SEWAGE DISPOSAL SYSTEM

HOWARD COUNTY HEALTH DEPARTMENT

SUBDIVISION LOT 11 ROAD 11880 Triadelphia Road

PROPERTY OWNER Gebhart, Arthur

A 32880

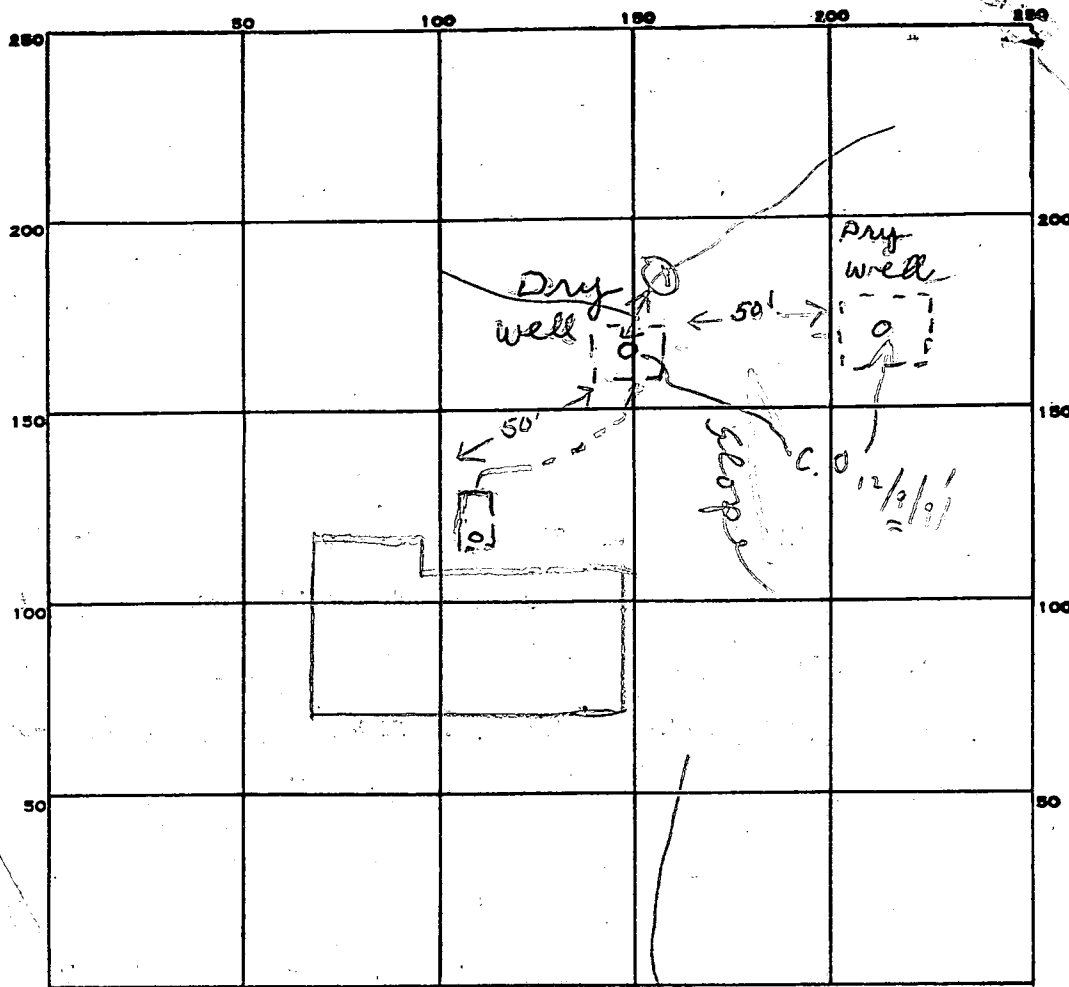
REMARKS 8/1/83 Work OK - OK to cover. Switching
 device on dry wells not used.

A 18209

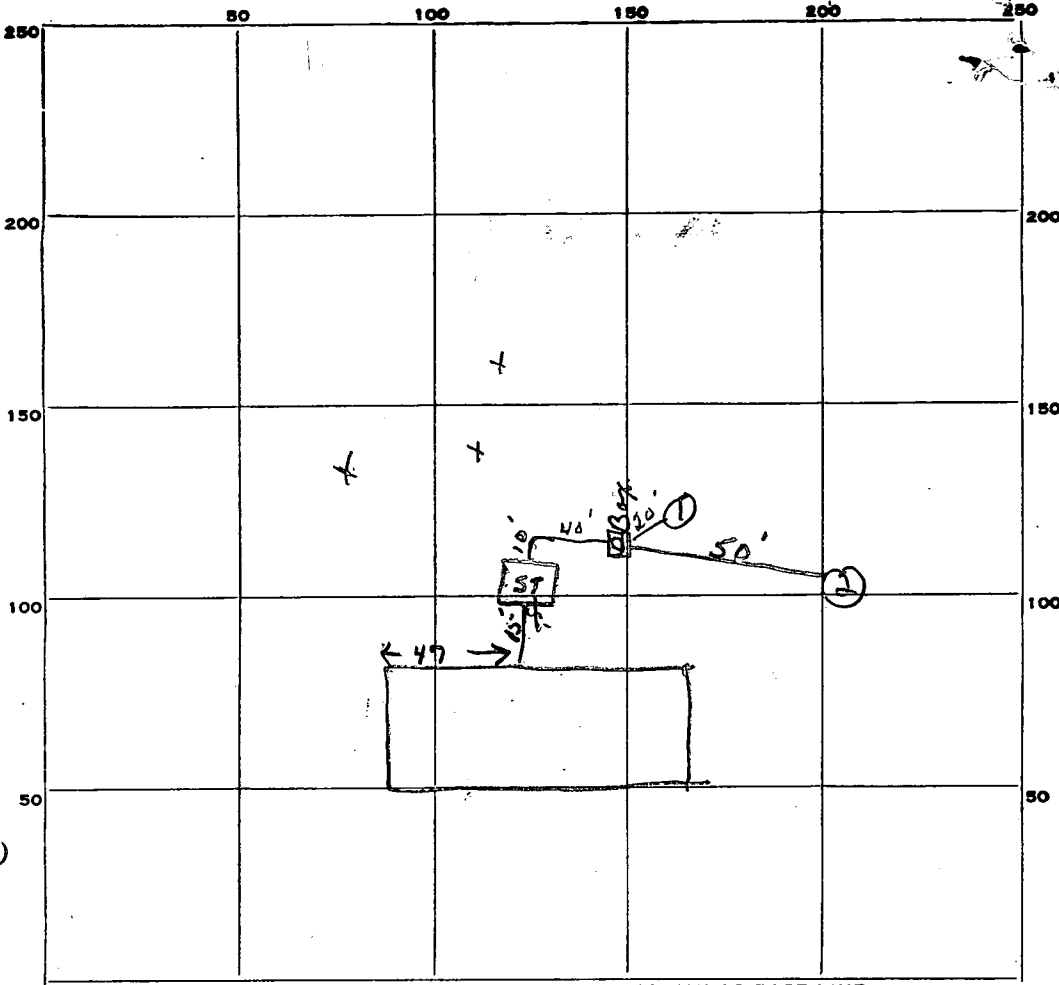
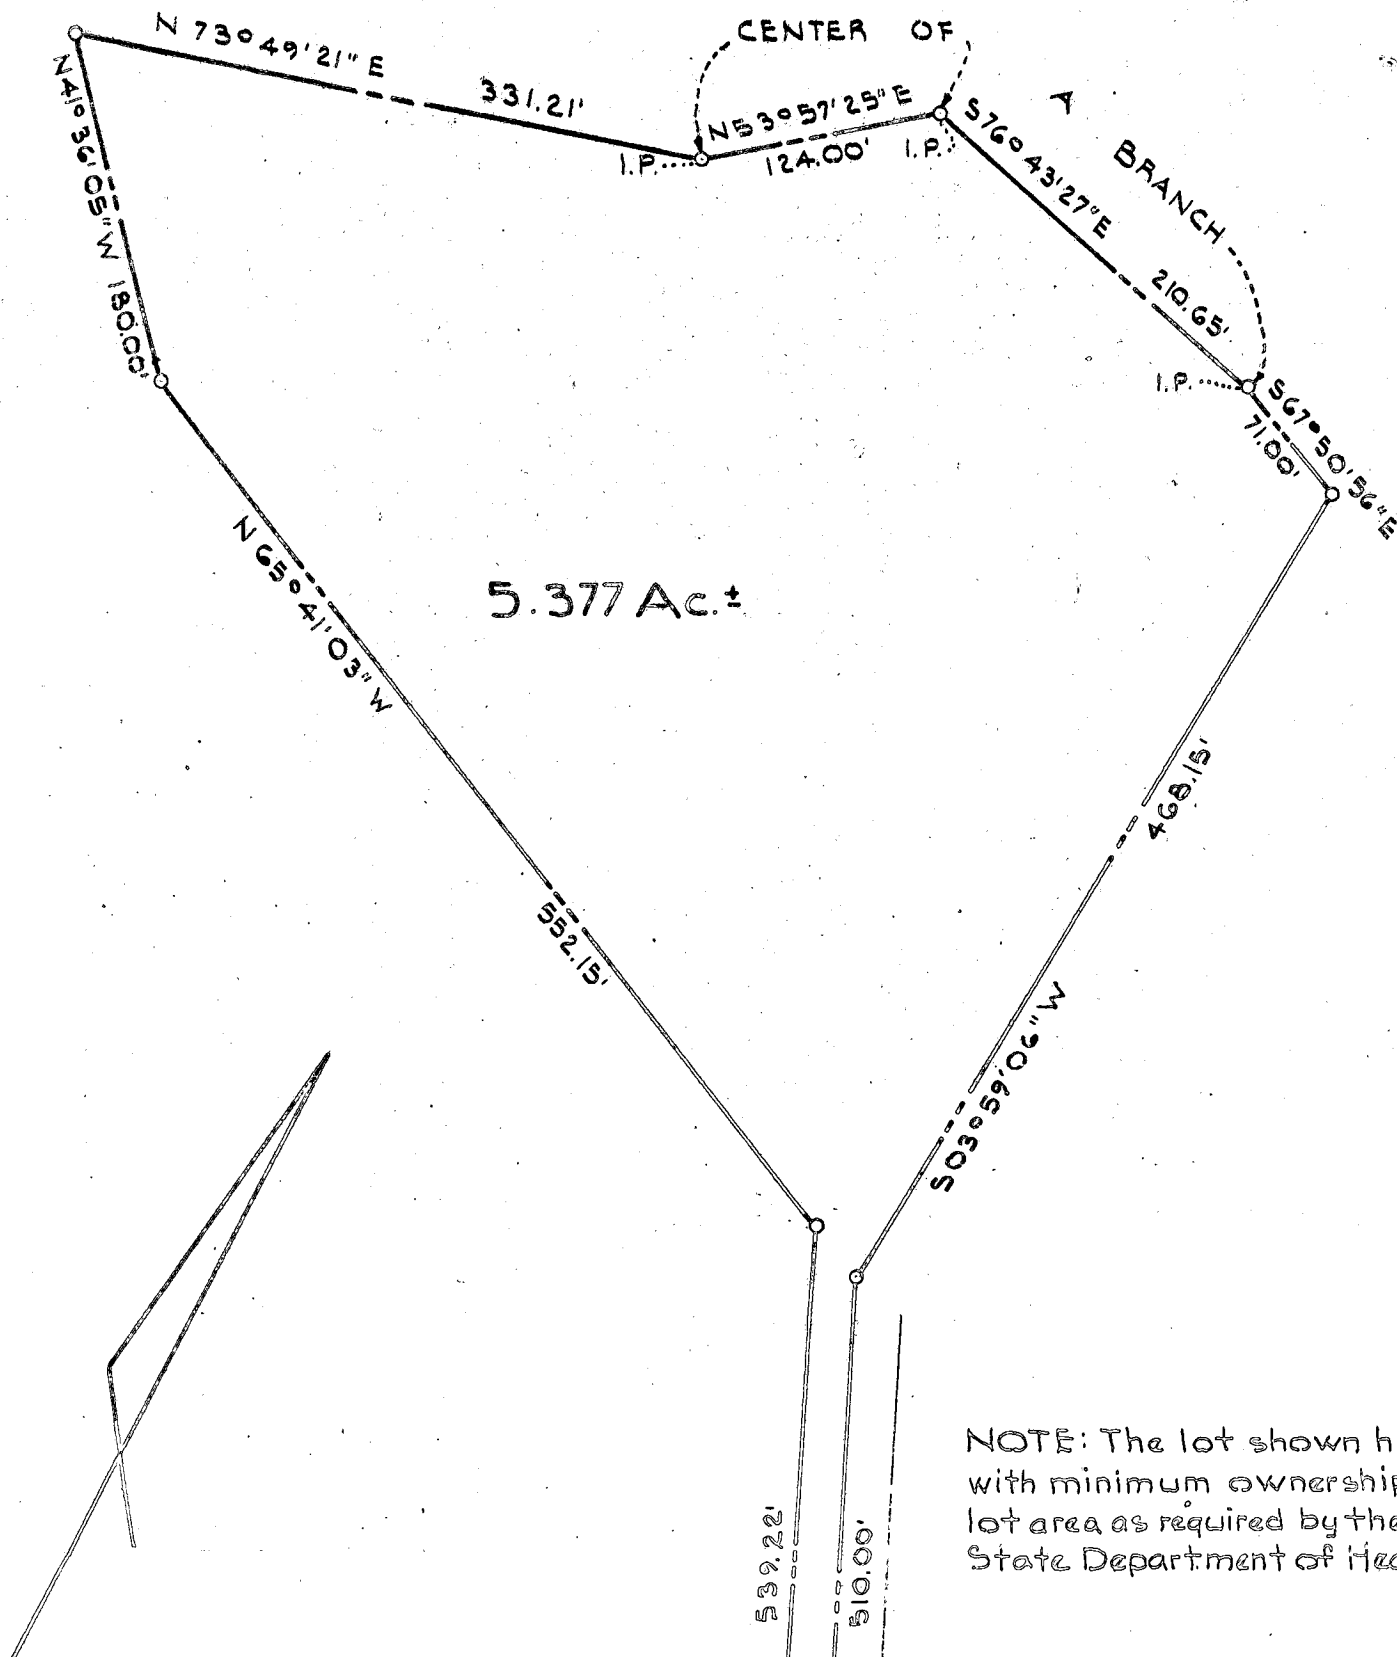
REMARKS 7/26/74 Hole one (1) dug to 10 ft - Hole (2) dug to 11 1/2 ft. Sandy soil
OK to complete dry wells. Septic tank to be
kept shallow so repairs can be made in higher area, (XXX)
by coming off septic tank.
7/31/74 - Give OK to backfill when cleanouts are installed,
call when line from house to tank is installed.

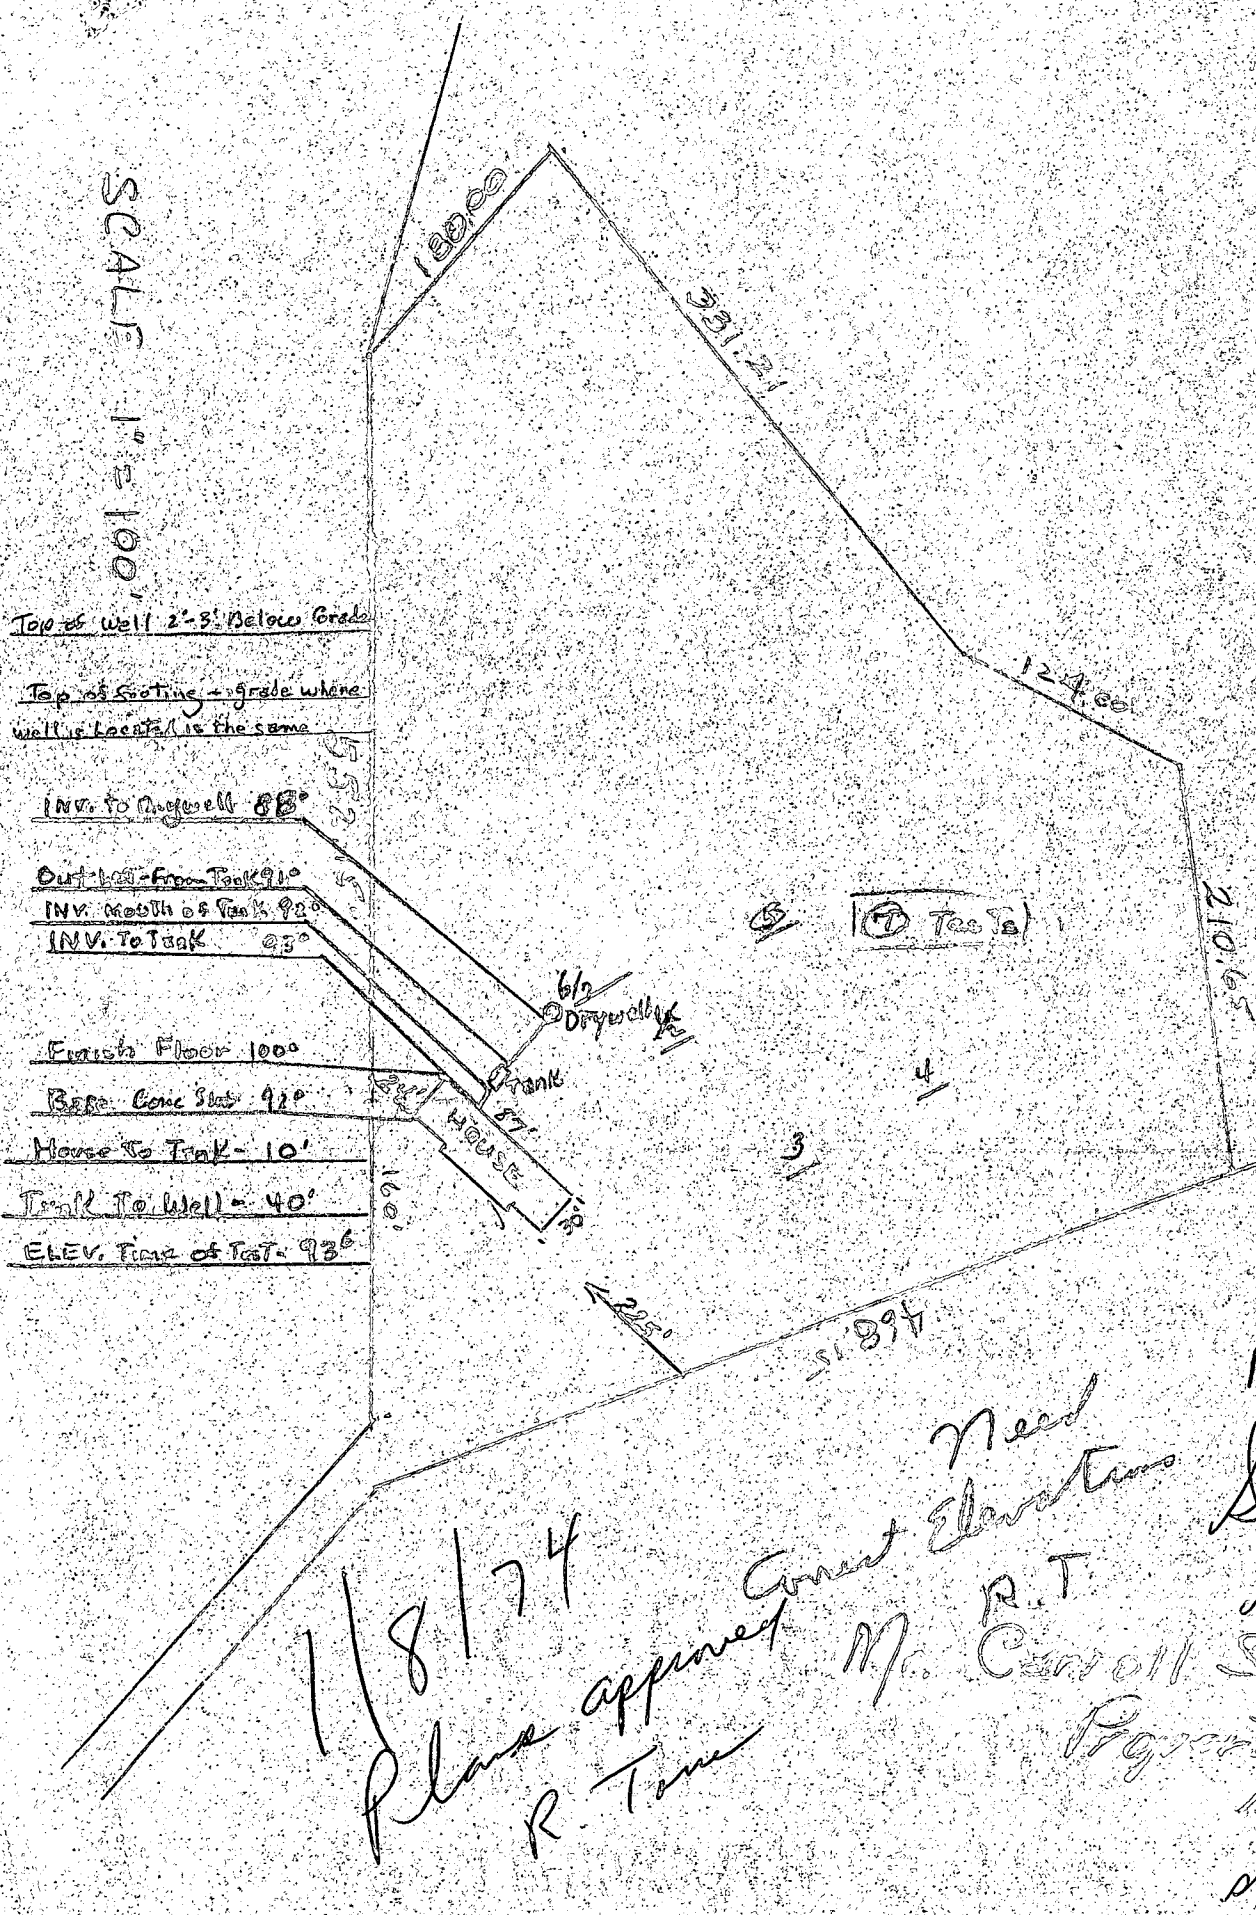
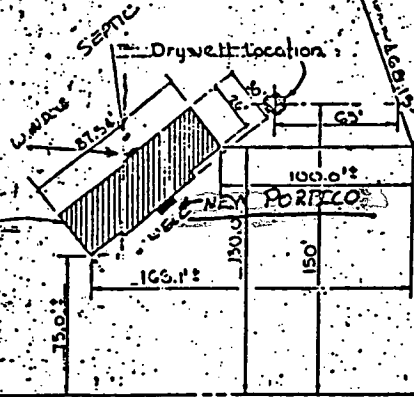
Need correct Elevation
R.T.
M. Carroll S. H.

1/8/74
Show that location of dry well is at point specified on plat
R.T.
